Product Change Notification / SYST-21QLVX434

ERRATA - dsPIC33EPXXXGM3XX/6XX/7XX Family Silicon Errata and Data Sheet Clarification Document Revision

dsPIC33EPXXXGM3XX/6XX/7XX Family Silicon Errata and Data Sheet Clarification

FIGURE 1: TIMING DIAGRAMS FOR CENTER-ALIGNED AND EDGE-ALIGNED MODES

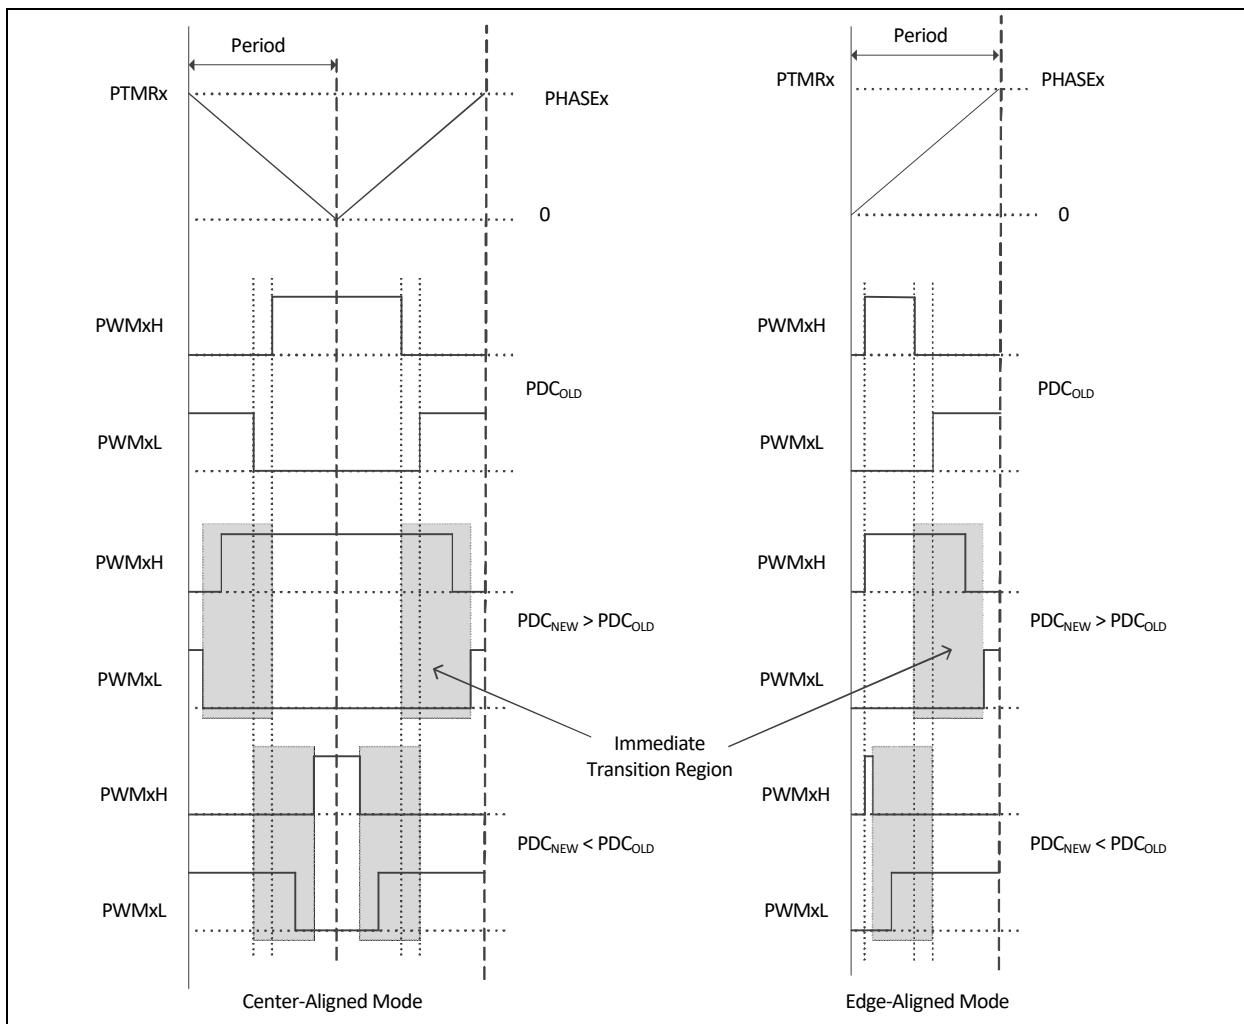
6. Module: PWM

The PWM generator may not assert dead time on the edges of transitions. This has been observed when all of the following conditions are present:

- The PWM generator is configured to operate in Complementary mode with Independent Time Base (ITB) or master time base;
- Immediate update is enabled; and
- The value in the PDC register is updated in such a manner that the PWMxH and PWMxL outputs make an immediate transition.

In Figure 1, if the duty cycle write occurred in the shaded box, then PWMxH and PWMxL will make an immediate transition without dead time.

Work around

None.

In most applications, the duty cycle update timing can be controlled using the TRIGx trigger, or Special Event Trigger, such that the above mentioned conditions are avoided altogether.

FIGURE 2: PWM GENERATOR TIMING DIAGRAM

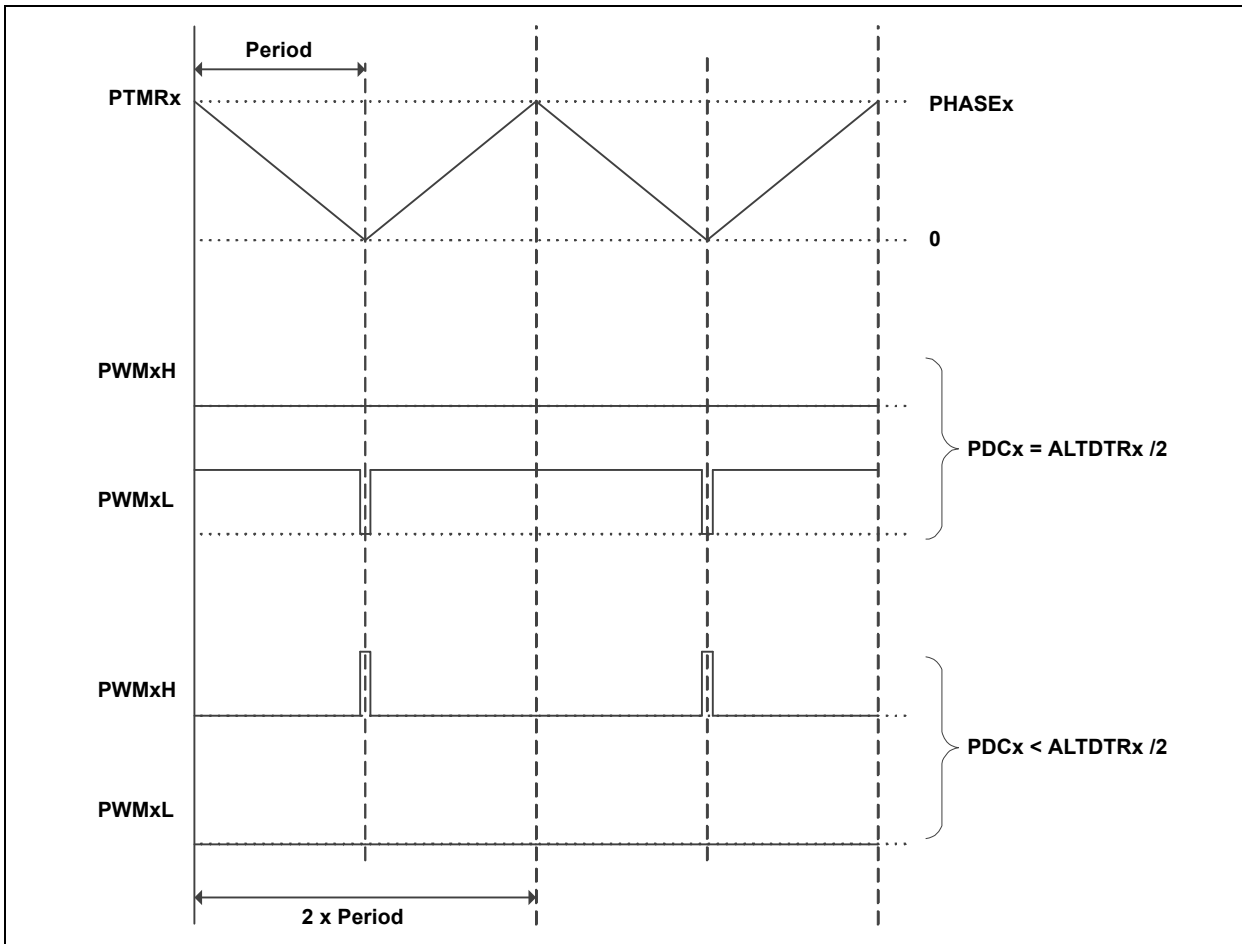
9. Module: PWM

In Center-Aligned Complementary mode with Independent Time Base, if the value in the PDCx register is less than one-half the value in the ALTDTRx register, the PWM generator will force the PWMxL to low, and on the PWMxH, generates pulses of a width less than twice the dead time, as shown in Figure 2.

Include a software routine to ensure that the duty cycle value written to the PDCx register is at least one-half of the value in ALTDTRx. Example 1 shows one method, with PDCtemp representing the variable which has the value to be written to the PDCx register. Alternatively, for duty cycle values less than half the desired dead-time value, zero out the ALTDTRx register or dynamically reduce the value in the ALTDTRx register, such that ALTDTRx is always equal to $2 * PDCx$, as shown in Example 2.

```
Altdtr_by2 = ALTDTRx / 2;
if (PDCtemp < Altdtr_by2)
{
PDCx = Altdtr_by2;
}
else
{
PDCx = PDCtemp;
}
```

```
#define DESIRED_DEADTIME 100
if (PDCtemp < (DESIRED_DEADTIME/2))
{
ALTDTRx = PDCtemp * 2;
PDCx = PDCtemp;
}
else
{
ALTDTRx = DESIRED_DEADTIME;
PDCx = PDCtemp;
}
```

FIGURE 3:

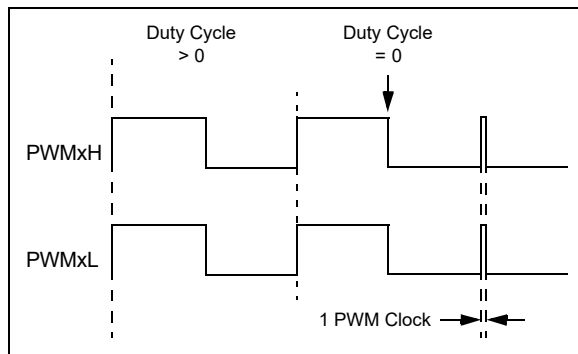
12. Module: PWM

In certain output modes, the PWMx module produces a pulse glitch of one PWM clock in width (Figure 3). This has been observed only when all of the following are true:

- Either Redundant or Push-Pull Output mode is selected (IOCONx[11:10] = 10 or 01);
- Immediate Update is disabled (PWMCONx[0] = 0); and
- The value of the current Duty Cycle register (either the PDCx or MDC register, as determined by PWMCONx[8]) is updated to zero from any non-zero value.

The pulse glitch has been observed to occur at the beginning of the following PWM boundary period.

If the application requires a duty cycle of zero, two possible work arounds are available.

1. Use the PWM overrides to force the output to a low state, instead of writing a '0' to the Duty Cycle register. When using this method, the PWM override must be disabled when the duty cycle is a non-zero value. If output override synchronization is configured to occur on CPU clock boundaries (IOCONx[0] = 0), enabling and disabling the override must be timed to occur as closely as possible to the PWM period boundary.
2. Configure the module for Immediate Update (PWMCONx[0] = 1) *before* enabling the module. In this mode, writes to the Duty Cycle register have an immediate effect on the output. As with the previous work around, writes to the Duty Cycle register must be timed to occur as close to the PWM period boundary as possible in order to avoid distortion of the output.

FIGURE 4:

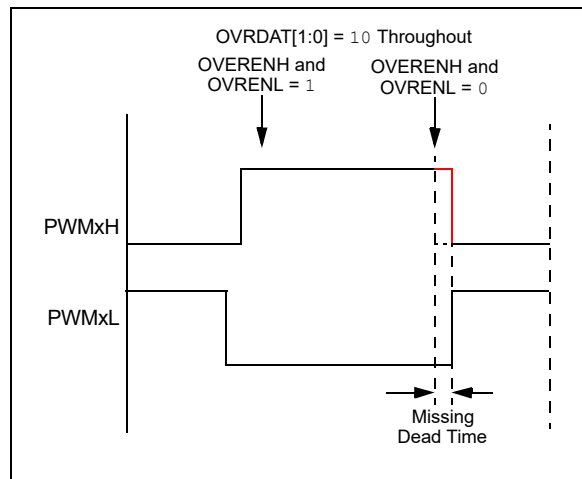
13. Module: PWM

In Complementary Output mode, the expected dead time between transitions of the PWMxH and PWMxL outputs may not be asserted when the following occurs:

- Output override synchronization is configured to occur on the CPU clock boundary (IOCONx[0] = 0);
- Both PWMxH and PWMxL overrides are enabled prior to the event (OVRENH and OVRENL are both '1'), and
- Both overrides are disabled (OVRENH and OVRENL are both '0') at the instant the dead time should be asserted (Figure 4).

This has been observed in both Center-Aligned and Edge-Aligned modes.

None.

FIGURE 5:

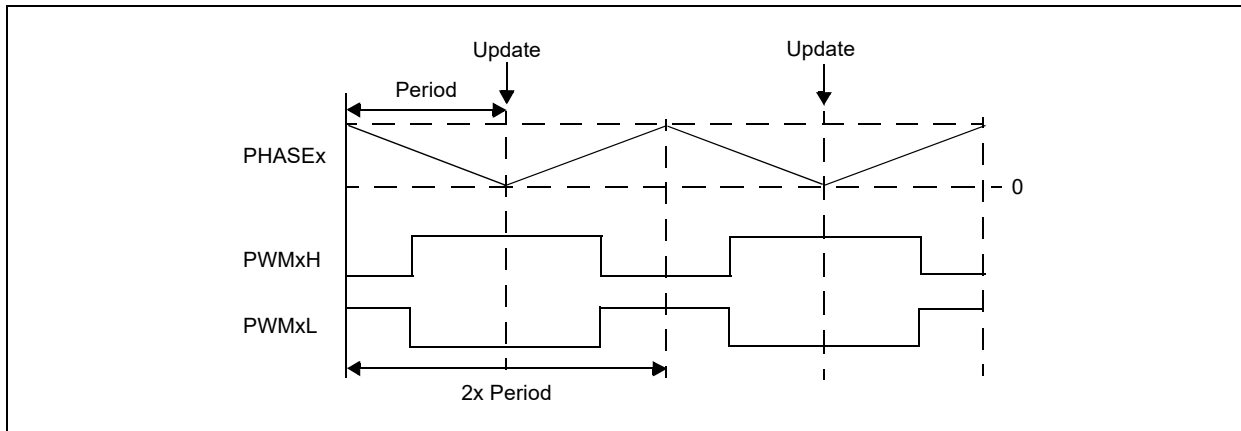
27. Module: PWM

In Center-Aligned Complementary mode with Independent Time Base, updates to the PHASEx register take effect in the middle of a Center-Aligned PWM cycle, as shown in Figure 5. This occurs only when the Immediate Update feature is disabled (IUE = 0). If Immediate Update is enabled (IUE = 1), the PHASEx register updates will take effect immediately.

FIGURE 6:

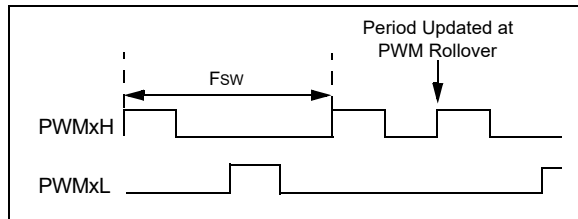
29. Module: PWM

When the PWM module is configured for Push-Pull mode (IOCONx[11:10] = 10) with the Enable Immediate Period Update bit enabled (PTCON[10] = 1), a write to the Period register that coincides with the period rollover event may cause the push-pull output logic to produce back-to-back pulses on the PWMx pins (Figure 6).

FIGURE 7: SIMPLIFIED BEHAVIOR

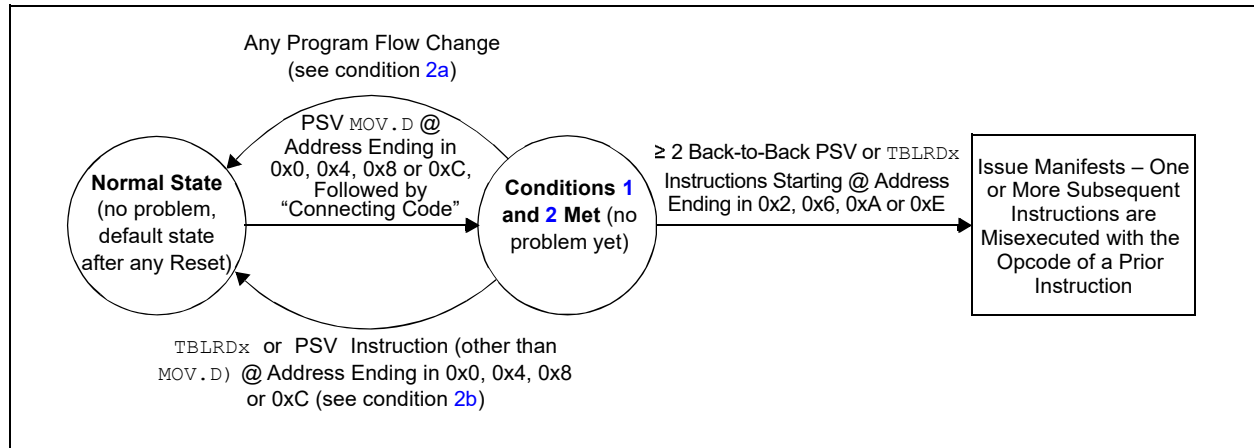
| 3. | ≥ 2 back-to-back PSV or TBLRDx instructions are executed (following the code of condition 2), where the first of the back-to-back instructions is located at an address ending in 0x2, 0x6, 0xA or 0xE. |

[Figure 7](#) provides an example of the effective behavior.

1. All instances of PSV MOV.D can be replaced with two PSV MOV instructions instead. Non-PSV MOV.D instructions acting on RAM/SFRs do not need to be modified; or
2. If not already present, a program flow change instruction (such as BRA \$+2) can be inserted above back-to-back data Flash read sequences; or
3. Back-to-back data Flash read instruction sequences can be broken up by inserting a non-Flash read instruction (such as a NOP), in between the Flash read instructions; or
4. The alignment of the code can be shifted to avoid the required opcode location addresses.

C code built with MPLAB® XC16 Compiler Version 1.32, or later, implements the work around by default. However, if the application uses Assembly language routines, these should be manually modified to implement the work around. Additionally, if precompiled libraries are used, these should be built with XC16 Version 1.32 or later. For additional information, please visit: www.microchip.com/erratum_psrds_psrds

64-Lead Plastic Quad Flat, No Lead Package (MR) – 9x9x0.9 mm Body with 5.40 x 5.40 Exposed Pad [QFN]

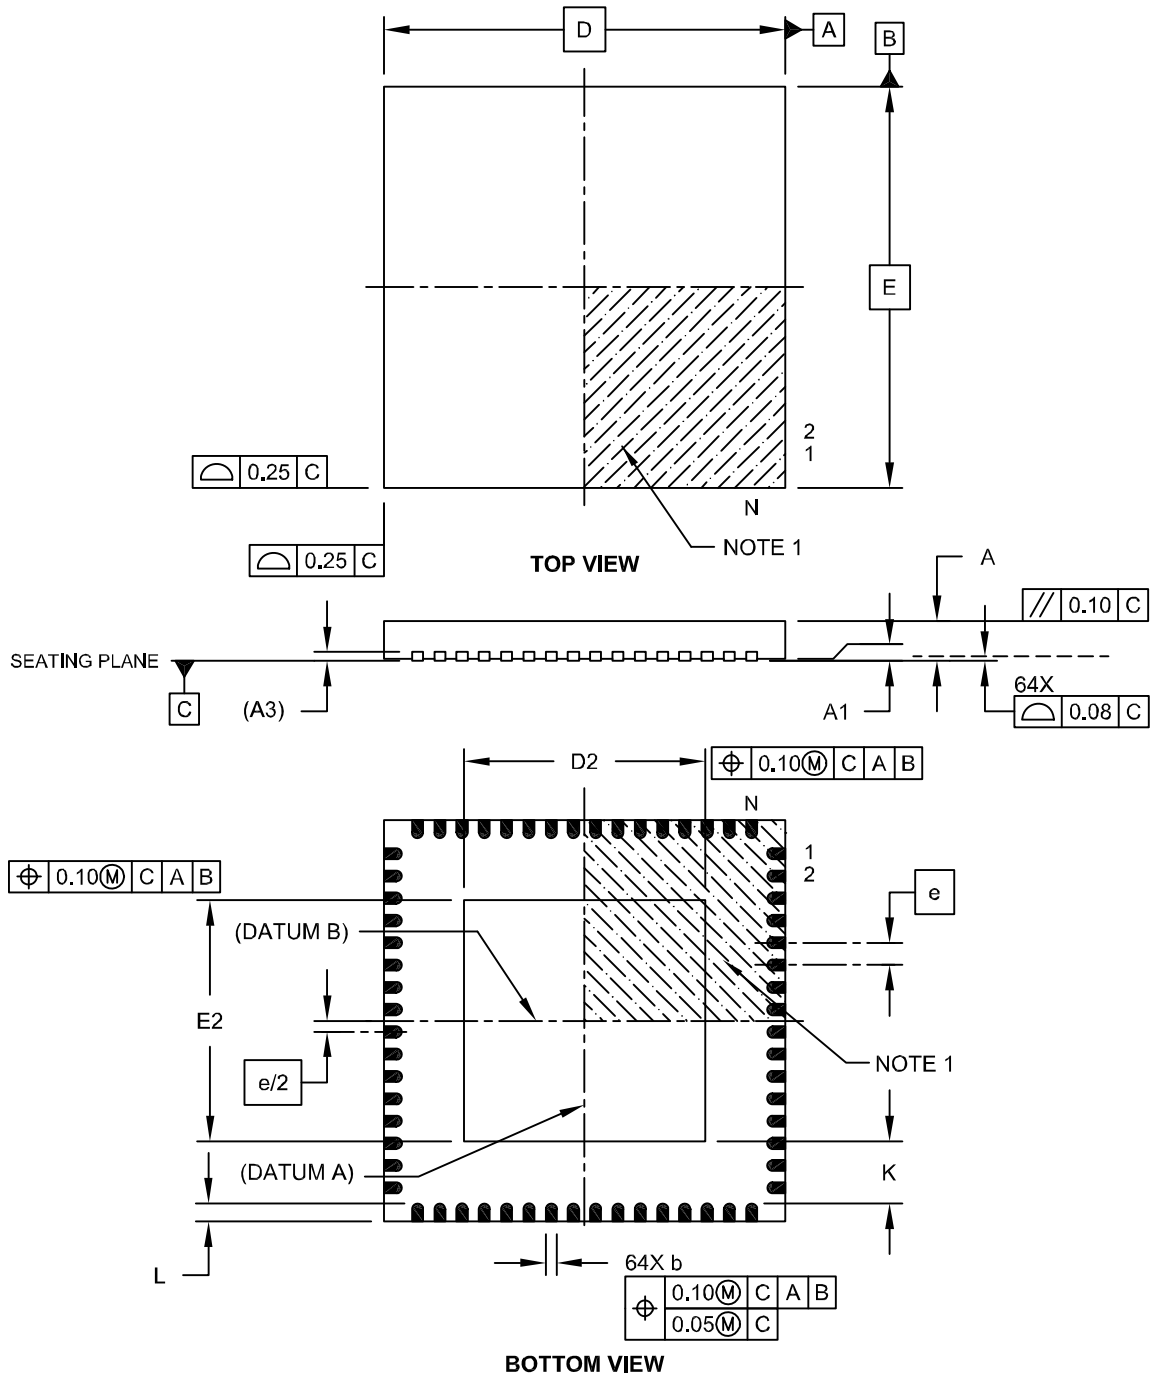
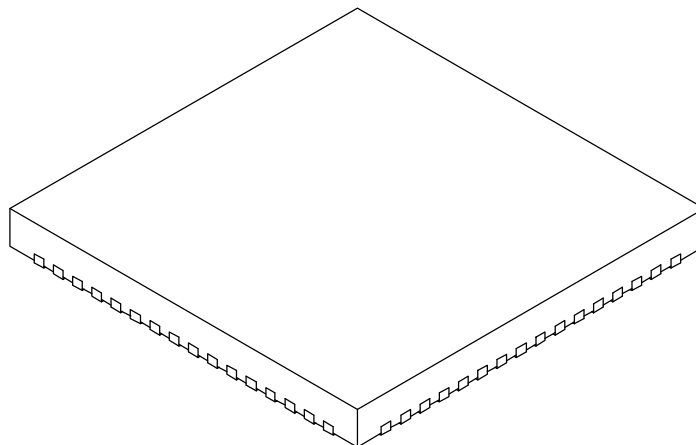
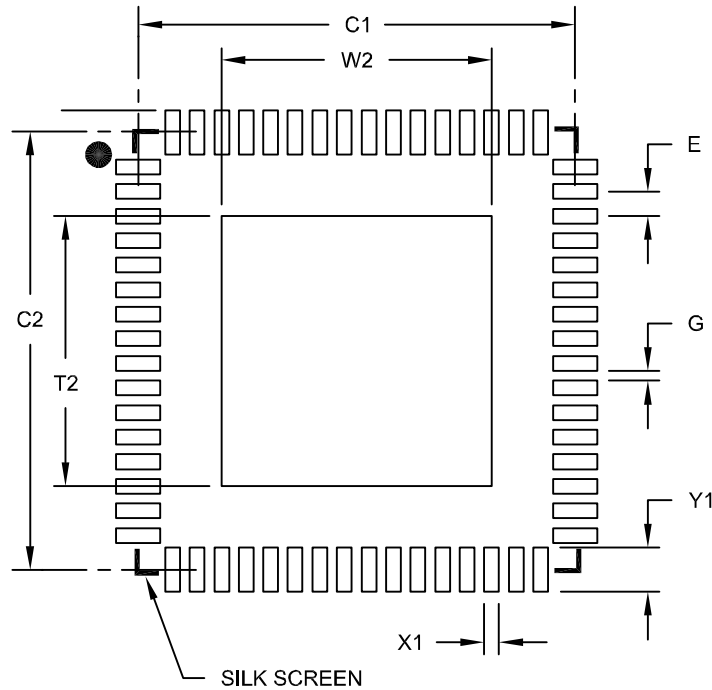
1. Module: Packaging Information

In the “*dsPIC33EPXXXGM3XX/6XX/7XX Family Data Sheet*”, **Section 35.2 “Package Details”**, dimensions for the 64-Lead Plastic Quad Flat, No Lead Package (MR) – 9x9x0.9 mm Body with 7.15 x 7.15 Exposed Pad [QFN] is mentioned. However, the dsPIC33EPXXXGM3XX/6XX/7XX family devices are not available in this package.

The dsPIC33EPXXXGM3XX/6XX/7XX family devices are available in the 64-Lead Plastic Quad Flat, No Lead Package (MR) – 9x9x0.9 mm Body with 5.40 x 5.40 Exposed Pad [QFN], and the package dimensions are shown on the following pages.
